ASSESSMENT REPORT

Salt Ash Sand Quarry Acoustic Fence Modification (MP 07_0094 MOD 3)

Figure 3: Detailed design of the approved acoustic bund

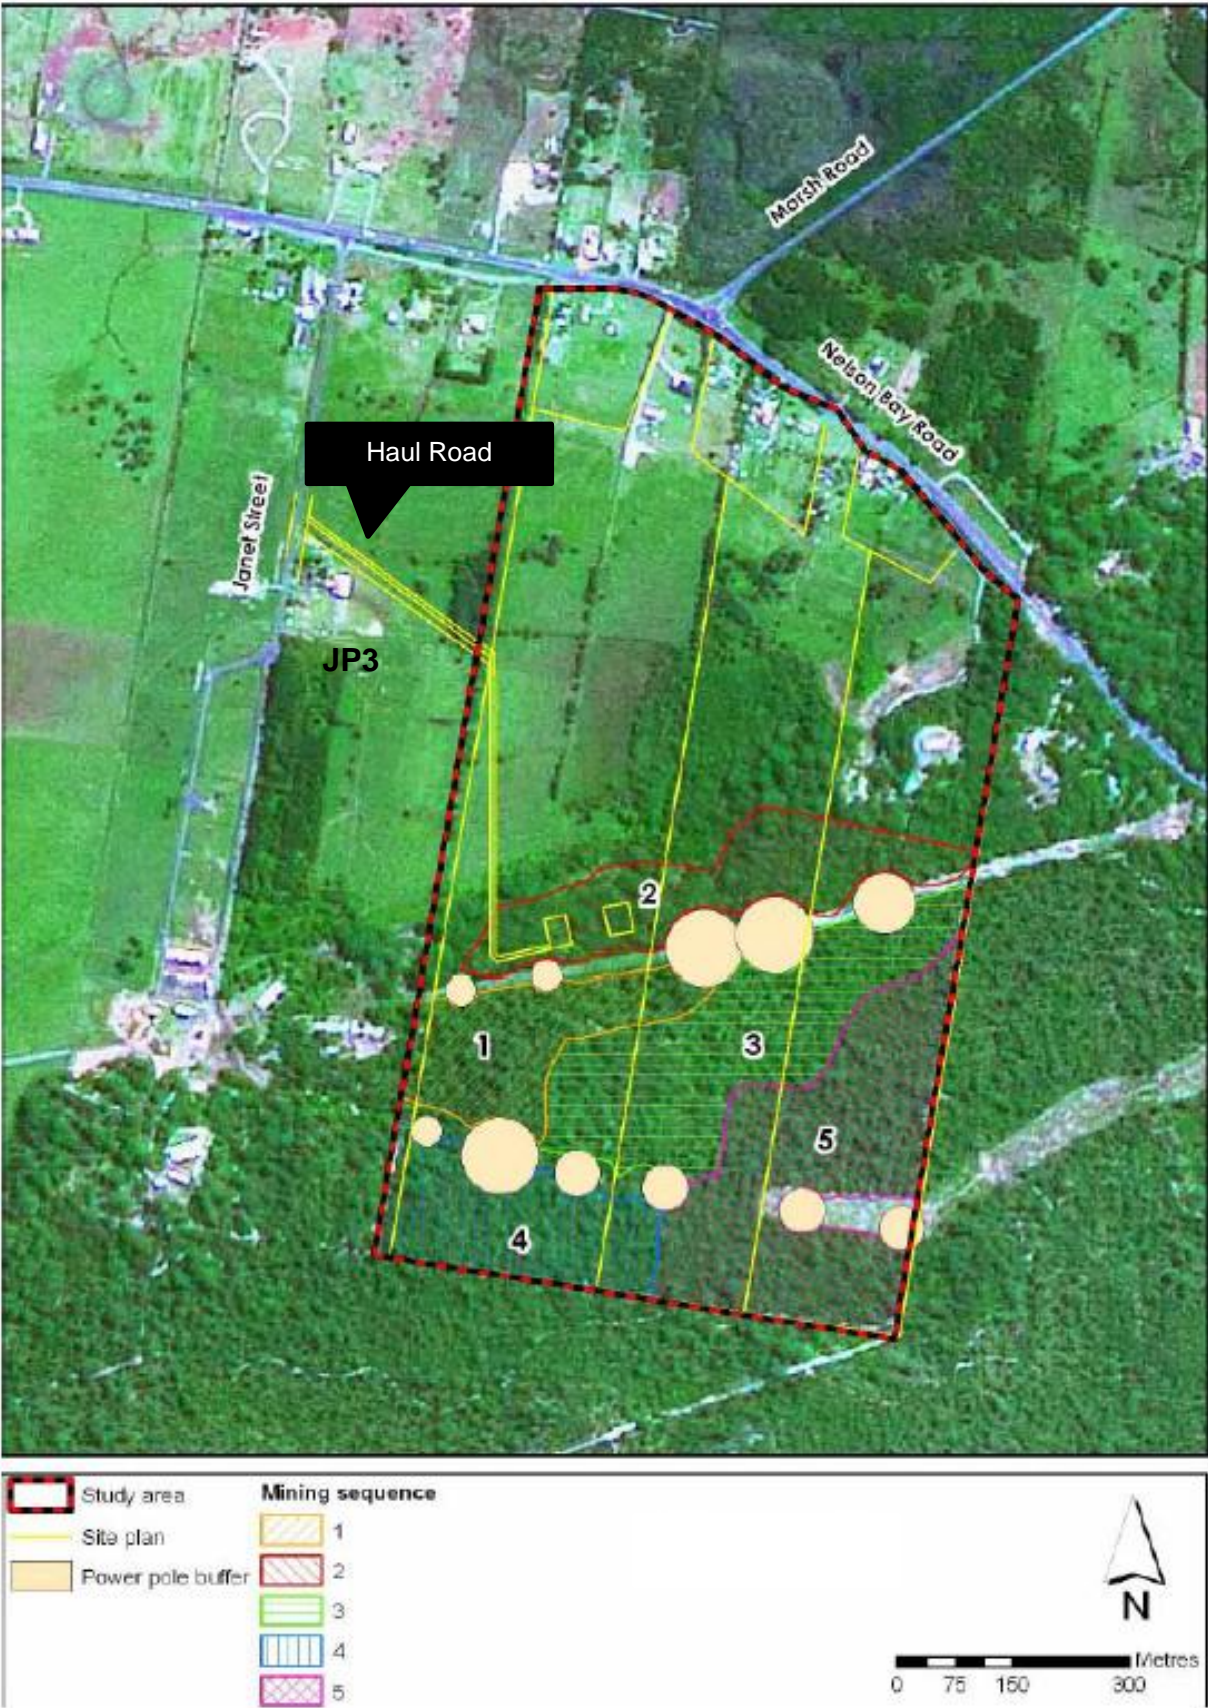
the southern boundary of the approved quarry access road (shown as the haul road in **Figure 2**). The construction of the bund commenced in accordance with design specifications detailed in the original Environmental Assessment (EA), which consisted of a fence atop a vegetated earth mound (see **Figure 3**).

Figure 4: New haul road route and electrical easement

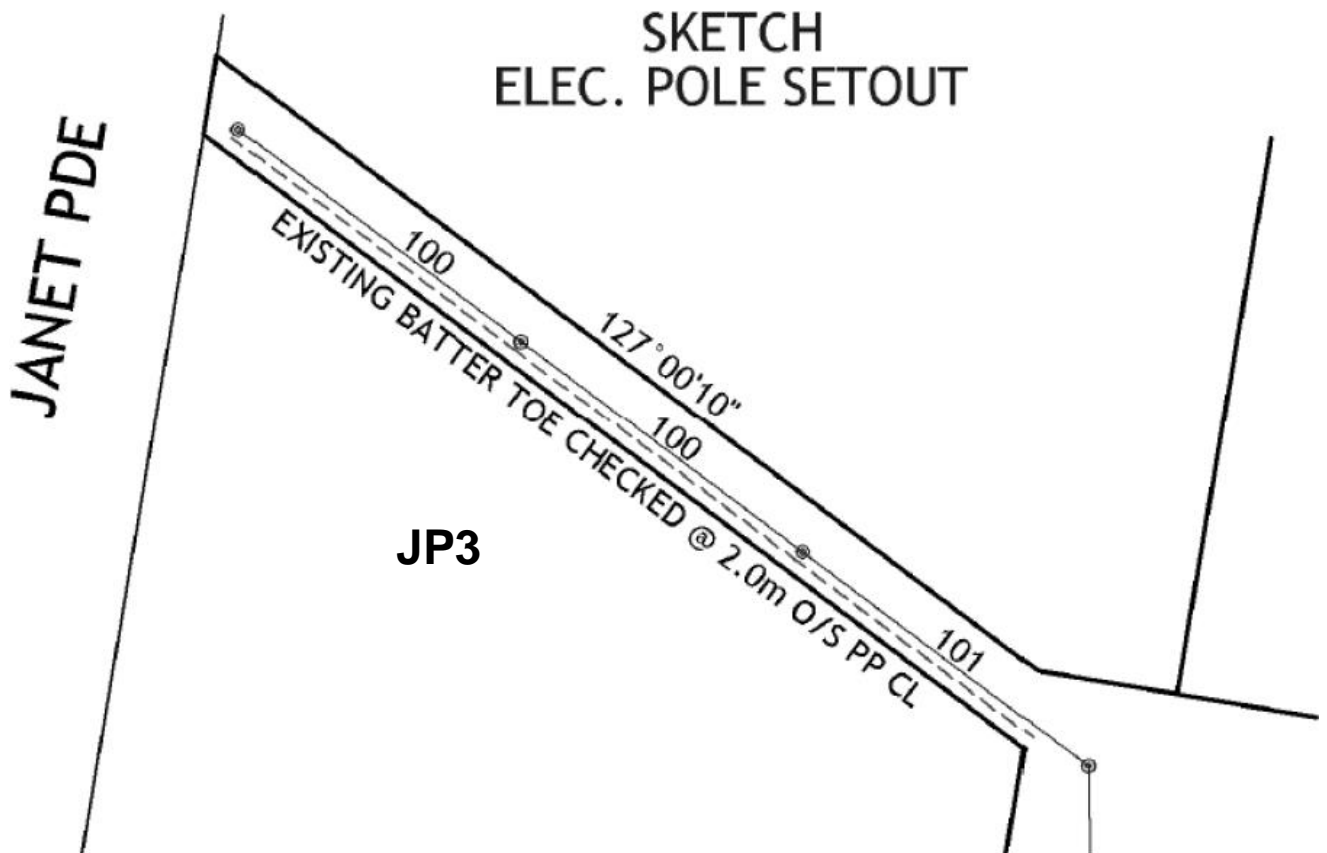
Prior to the completion of bund construction works, the preferred location of power supply infrastructure was identified by the quarry's energy service provider. The location of power supply infrastructure would run along the new haul road route, creating a 15 m wide easement corridor (see **Figure 4**). The design of the proposed bund would pose a potential safety risk to this corridor, which requires clear and unobstructed access. To accommodate this, ATB Morton has now removed all the components of the bund which it had commenced to construct.

Figure 5: Proposed acoustic bund design

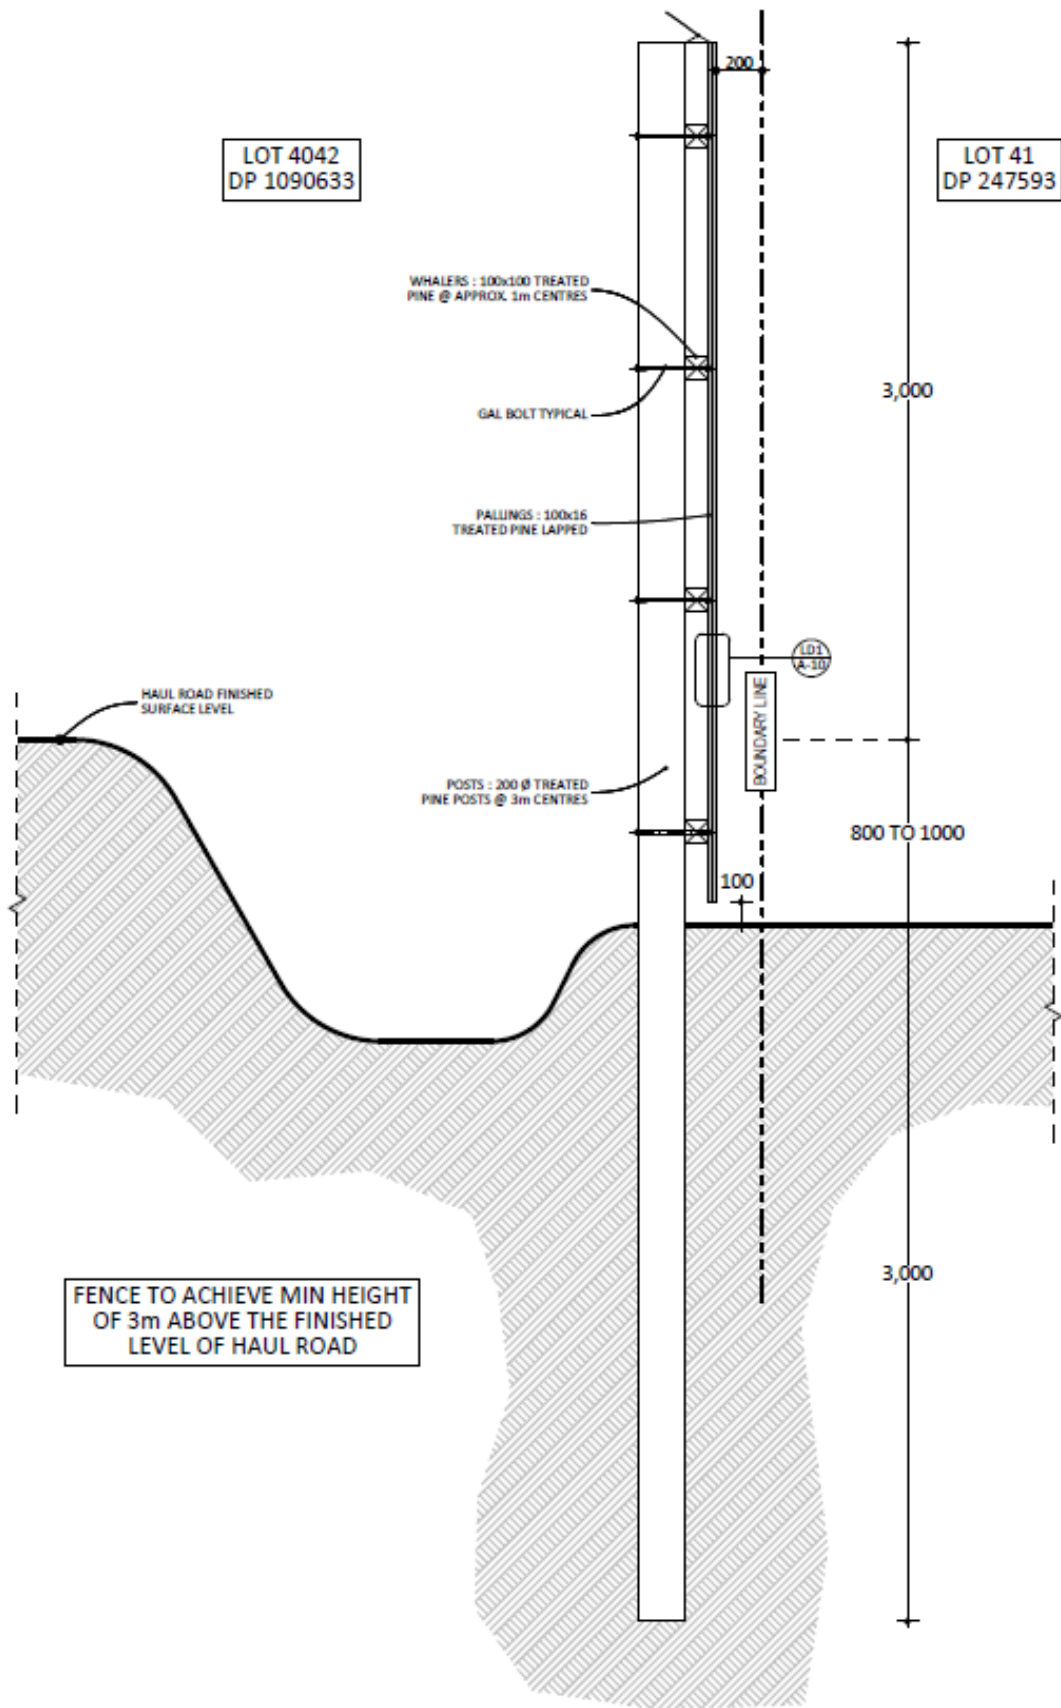
ATB Morton is proposing to replace the original design and location of the acoustic bund with an acoustic fence (see **Figure 5**), to be installed along the northern property boundary of Lot 41 (ie 'JP3').

The proposed treatment is essentially a wooden fence, up to 4 m in height, and up to 3 m in height above the level of the haul road. The fence would be faced with overlapping palings and its posts would be set deep in the ground to limit the chance of wind damage (see **Figure 5**).

A noise assessment was undertaken by Spectrum Acoustics to support the redesign. Noise predictions were based on real noise levels of trucks measured at JP3, the most affected location, during periods of simulated operations. The assessment predicted that noise levels would be below the noise criteria specified in the existing project approval.

While the redesign of the acoustic bund offers a less desirable visual outcome than the original design due to the lack of landscaping and vegetation, the only residence impacted by this redesign is JP3. ATB Morton has a negotiated agreement with the owners of JP3 to mitigate this visual impact and provide some compensatory works on their land. Furthermore, the Department has received a letter from the owner of JP3 in support of the application.

The Department is therefore satisfied that the redesign of the acoustic bund would not result in unacceptable noise and visual impacts to nearby residences and has recommended minor amendments to the conditions of approval to allow for the redesign.
